AMENDMENT TO APPROVED MDP 743:
1. UNIT BOUNDARY BETWEEN UNITS 3 & 4 ADJUSTED.

P.U.D./MASTER DEVELOPMENT PLAN for TALLEY ROAD 233

Re: Talley Road 233 (Amendment)

MDP # 743A

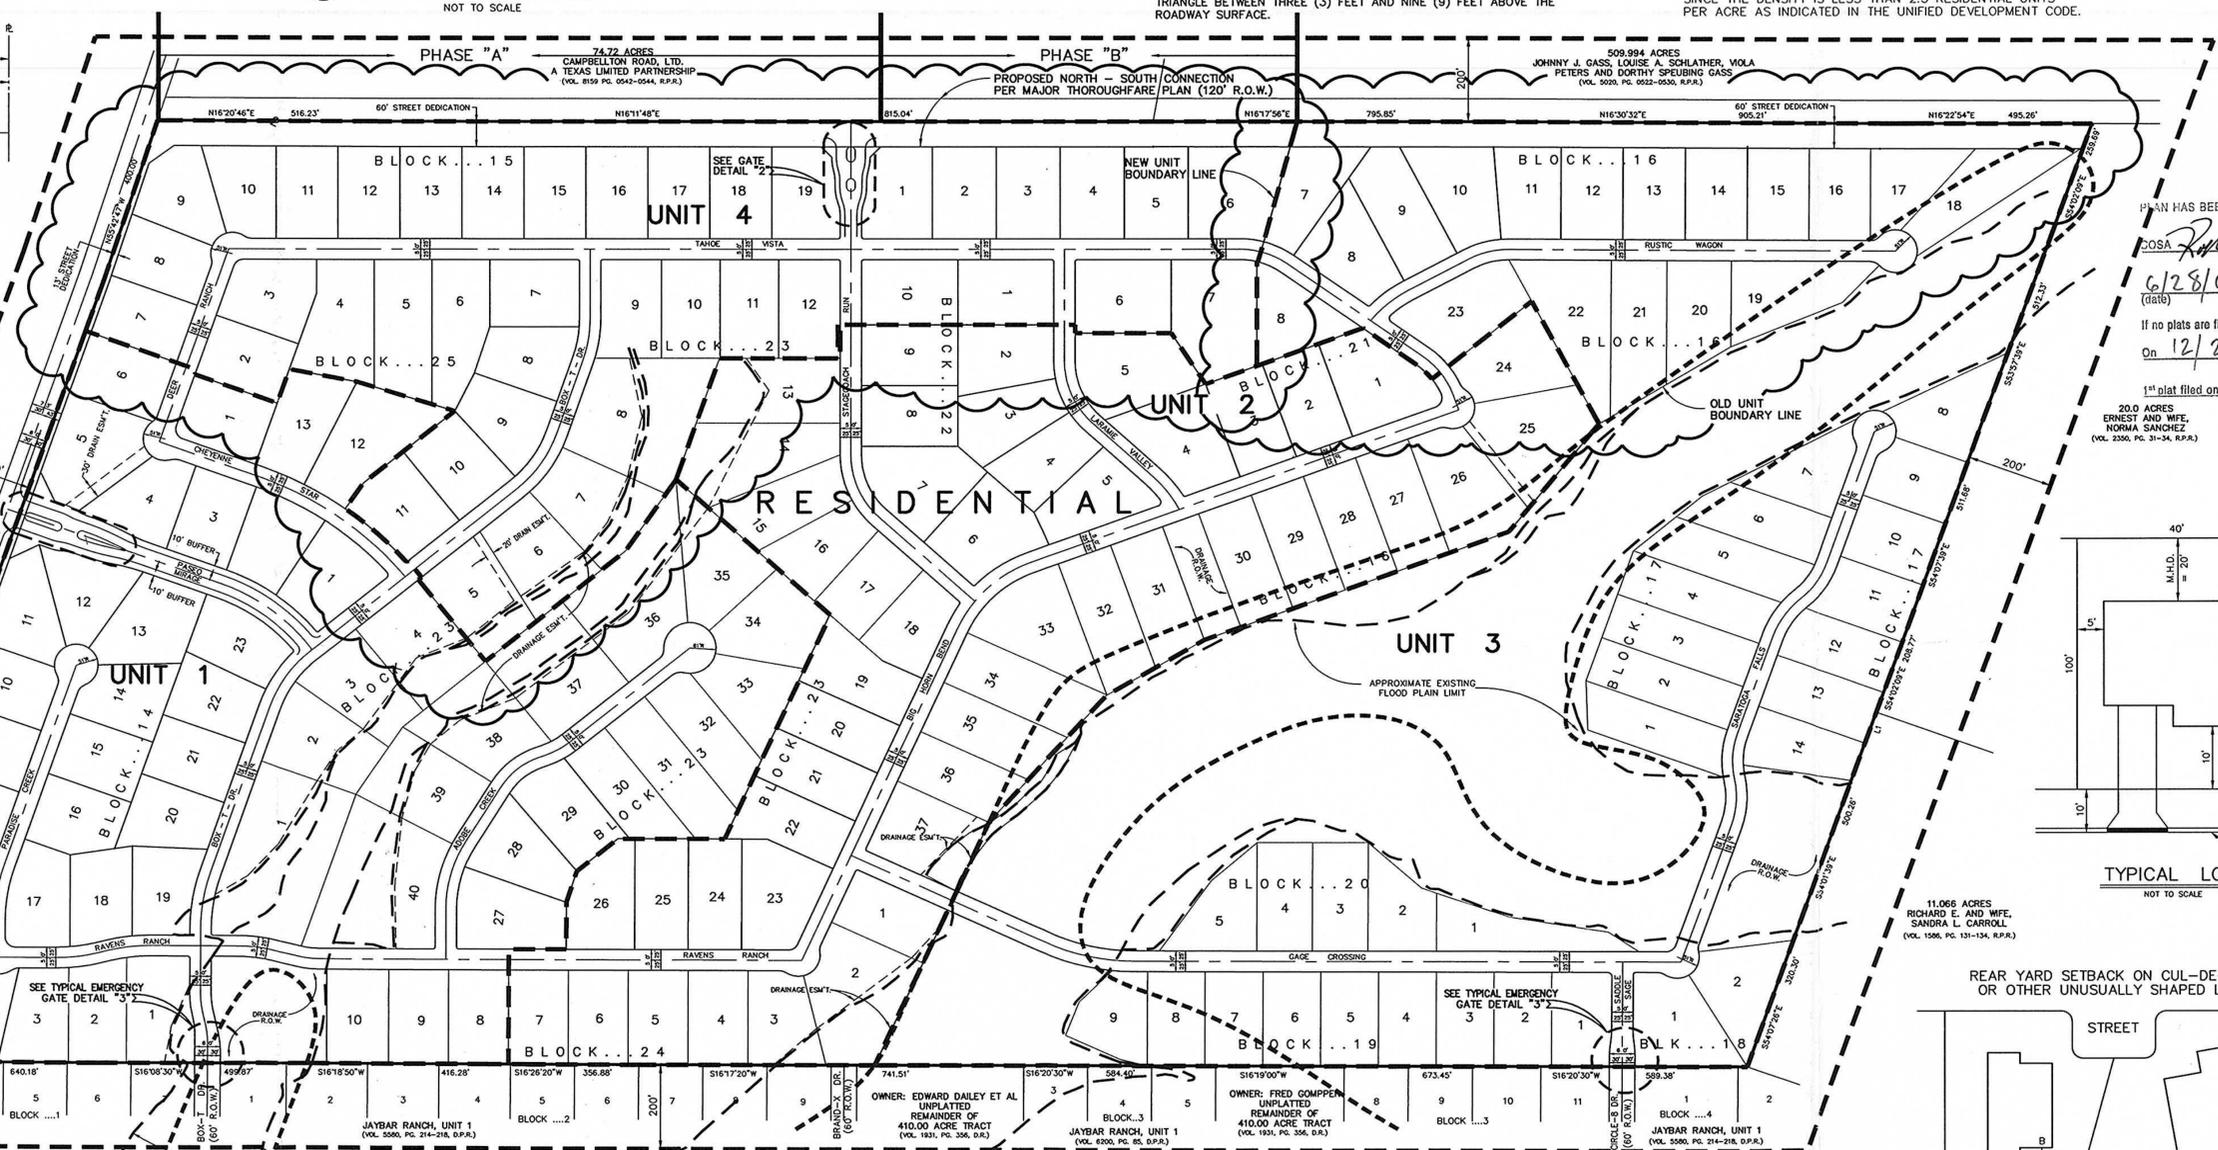
- a.) At the completion of the first unit for this development, the Developer shall provide 60 feet of ROW and construct half of the Primary Arterial Type “A” for the North – South connection adjacent to the west side of the proposed development. The length just described is approximately 4600 linear feet. This will require a property dedication by the developer.

- b.) The above requirement was not adhered to during the platting stage of this particular MDP. A note has been placed on the MDP amendment #743A to rectify the need for secondary access as per UDC 35-506 (e) (7). The remaining phases shall comply with the clouded notes placed on the amended Master Development Plan, MDP #743A.

- c.) All roadways within this development shall conform to the Low speed Design Ordinance #92670.

- UNIT 4 SHALL BE CONSTRUCTED BEFORE UNIT 3.
- PHASE "A" OF THE NORTH-SOUTH CONNECTION TO BE CONSTRUCTED WITH UNIT 4. PHASE "B" TO BE CONSTRUCTED WITH UNIT 3. DEVELOPER RESERVES THE RIGHT TO BUILD BOTH PHASE "A" & "B" WITH UNIT 4.
